Comments on “Improving semi-automated glacial mapping with a multi-method approach: areal changes in Central Asia”, by T. Smith et al, submitted to *The Cryosphere Discussion*

Wanqin Guo, December 2014

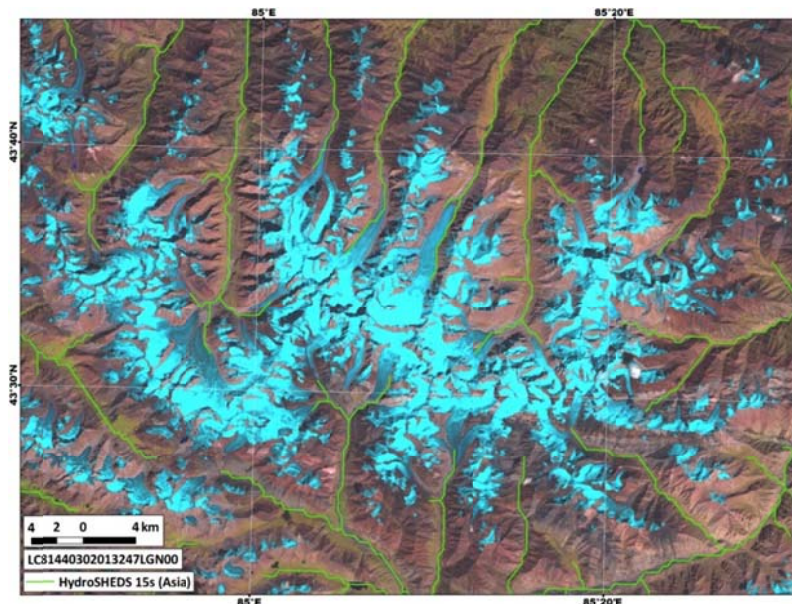
L27: I checked the HydroSHEDS 15s of Asia, and found that this data is very coarse in depict river networks,

and can only illustrate larger trunk rivers (see picture below). So I suspect that if using such river networks to determine the rationality of debris covered glacier area, it will eliminate many debris covered areas of small glaciers in this step, especially those cirque glaciers or small valley glaciers. Even by using 200m buffer, this situation cannot be well overcome. If it is solved by add manual seeds in second step, the manual workloads should be very heavy.
